CIVIL INTEGRATED WATER MANAGEMENT PLAN OPAL HEALTHCARE NARWEE PARKLANDS CARE COMMUNITY

**For SSDA
May 2023
Revision 6**

This Addendum /Integrated Water Management Plan has been prepared to support the Response to Submission Report for the Narwee Parklands Care Community State Significant Development Application (SSD-45024776) located at 59-67 Karne Street North, Narwee. The NSW Department of Planning and Environment (DPE) placed the Environmental Impact Statement and the accompanying technical documentation on public exhibition from 14 February 2023 until 13 March 2023. During the exhibition, a total of 22 submissions were received in response to the public exhibition of the EIS. These included submissions made by the State and Local Government agencies, authorities, as well as the general public.

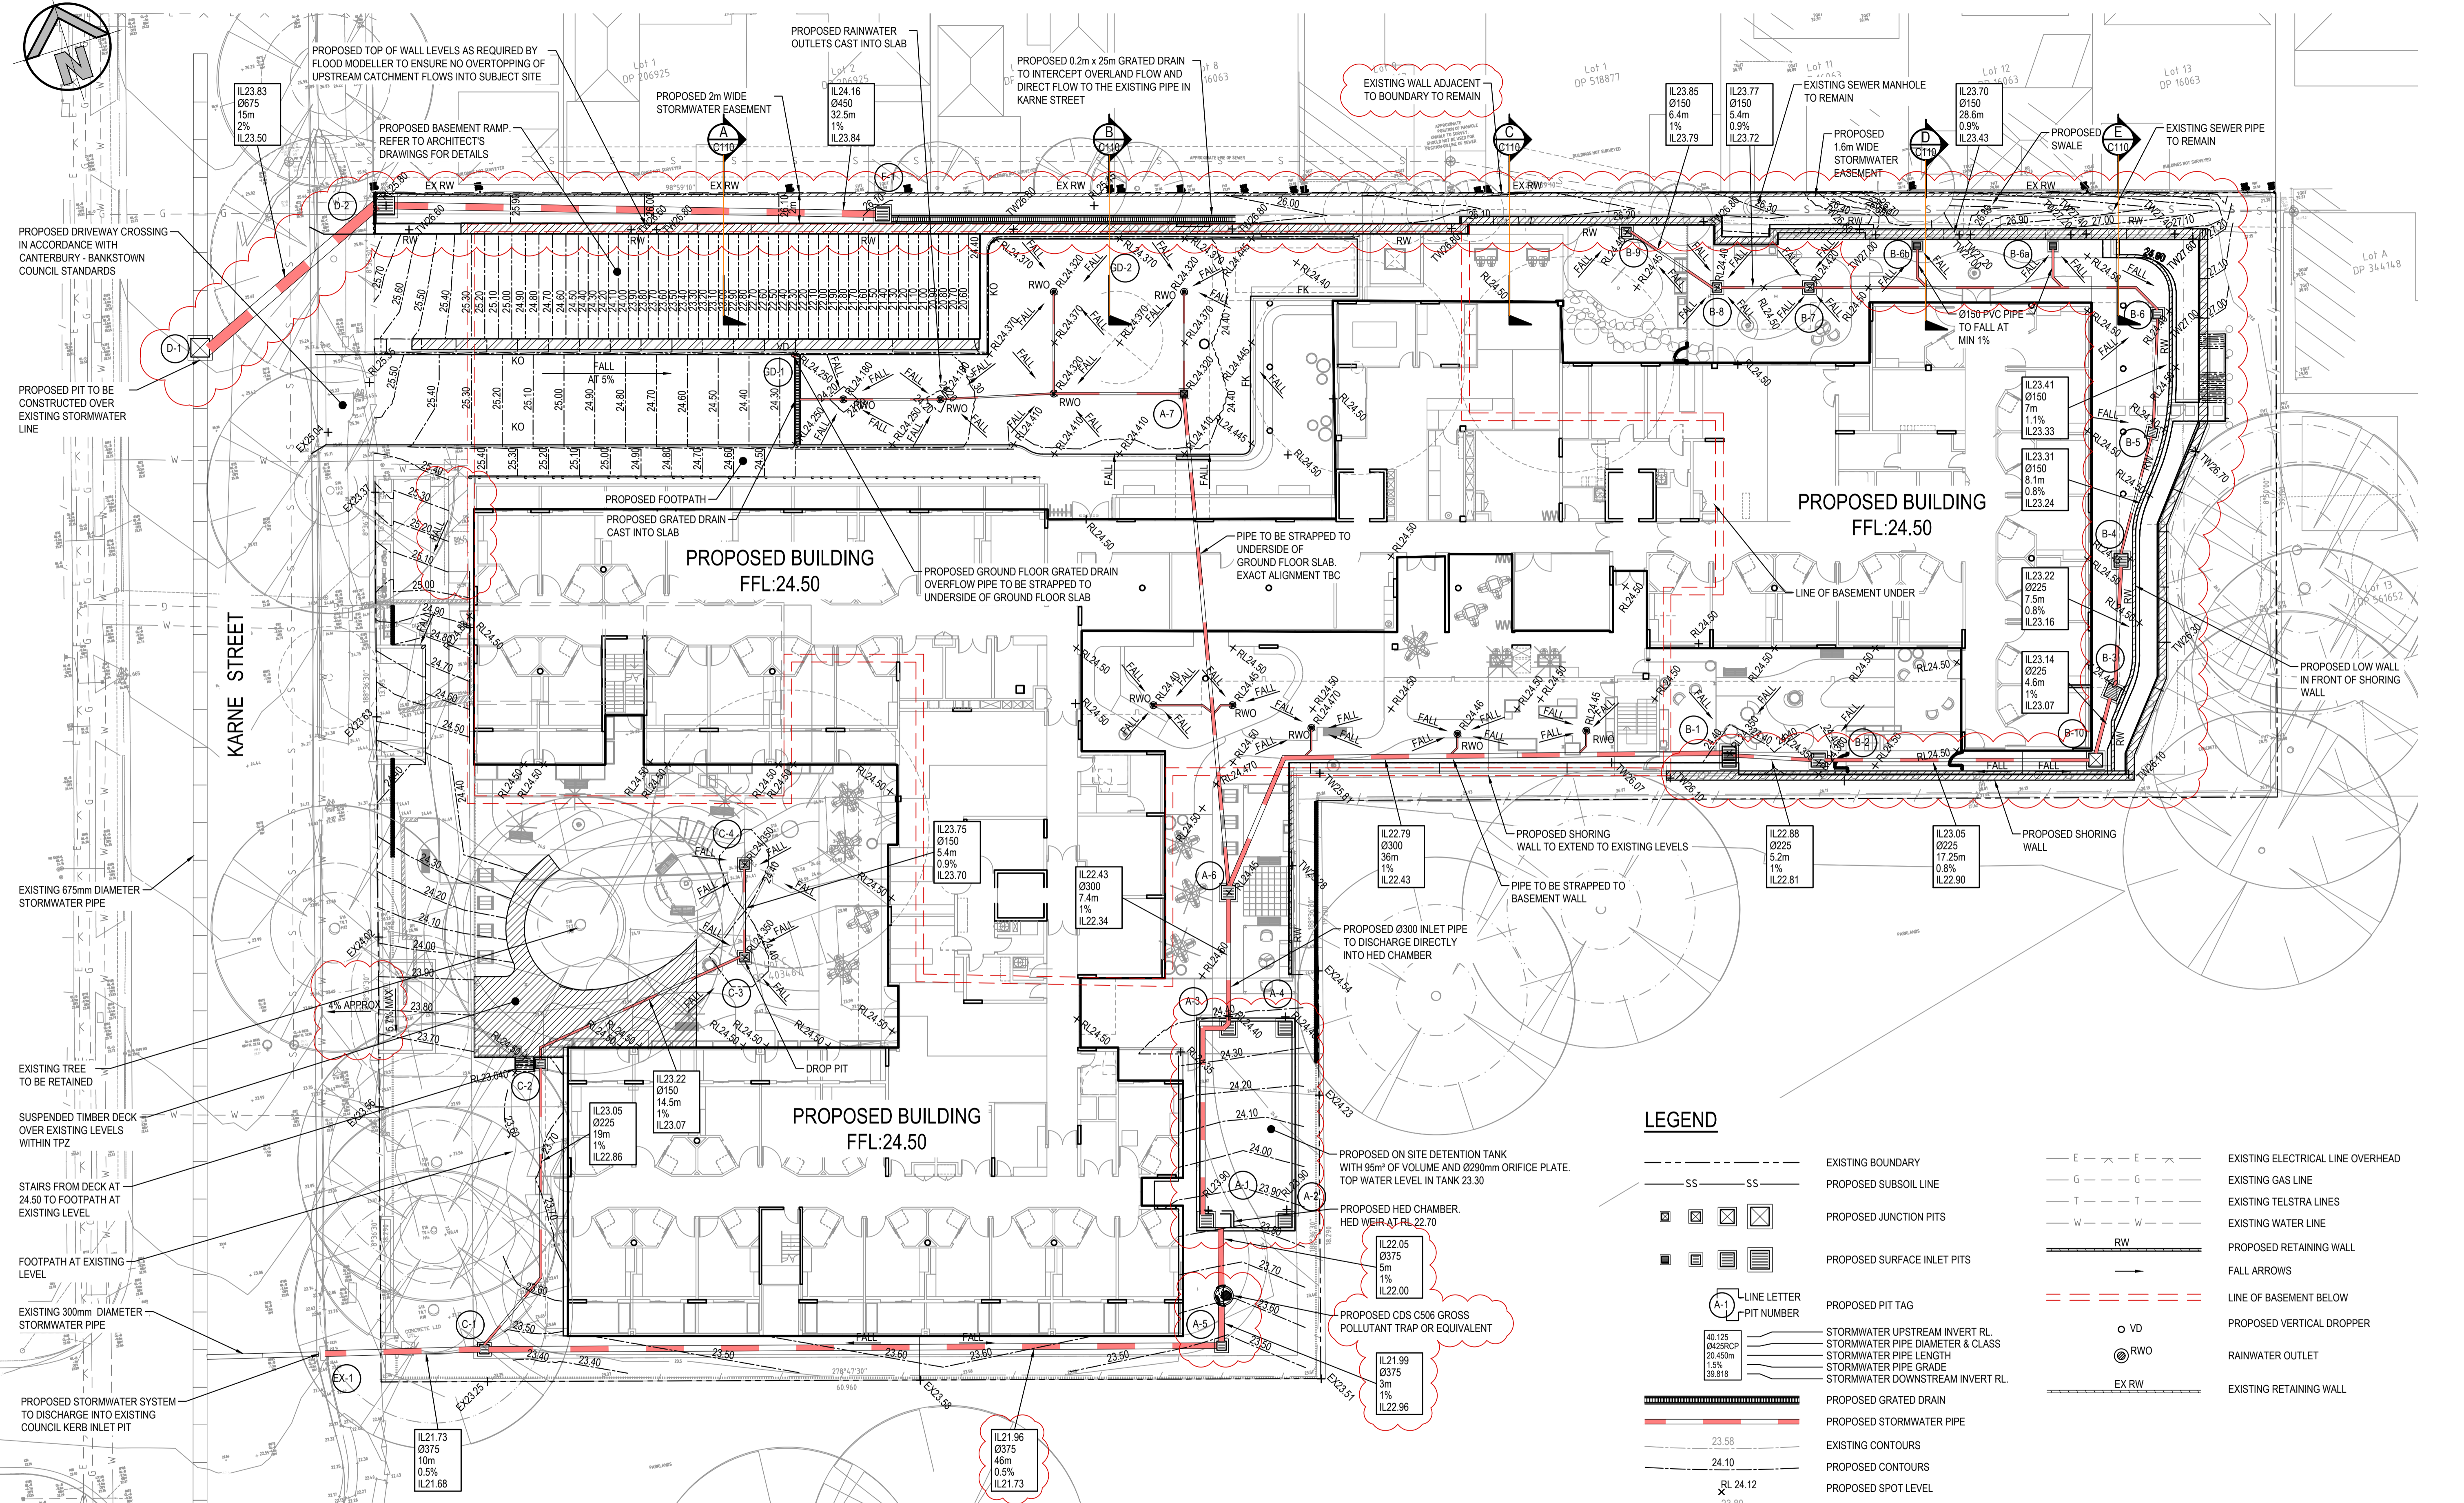
Ocean guard pit baskets and pollution control pits are not supported. It is requested a single gross pollutant trap is installed in lieu.

Refer to drawing C100 which now shows a gross pollutant trap to be installed in the southern part of the site. All reference to pit baskets and pollution control pits have been removed from the design.
